Subject: CORROSION AROUND SPOT WELDS IN TRUNK OPENING	Bulletin No: 09-011/16
	Last Issued: 02/23/2016

This bulletin supersedes the previously issued bulletin(s) listed below. The changes are noted below in Red beside the change bars.

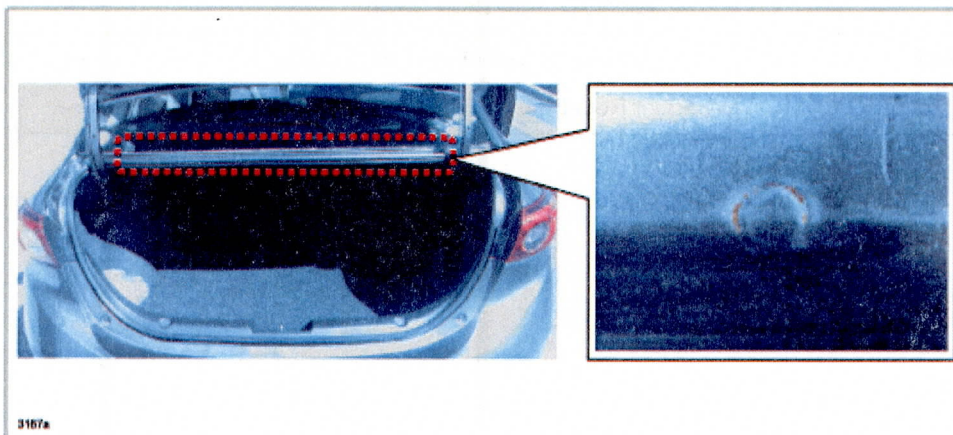
Some vehicles may exhibit corrosion around the spot welds in the trunk opening under the rear window. This is caused by insufficient paint thickness at the spot welds. To correct the problem, the paint thickness has been improved.

1. Verify customer concern.
2. Repair the rust damage on the panel.
3. Verify repair.
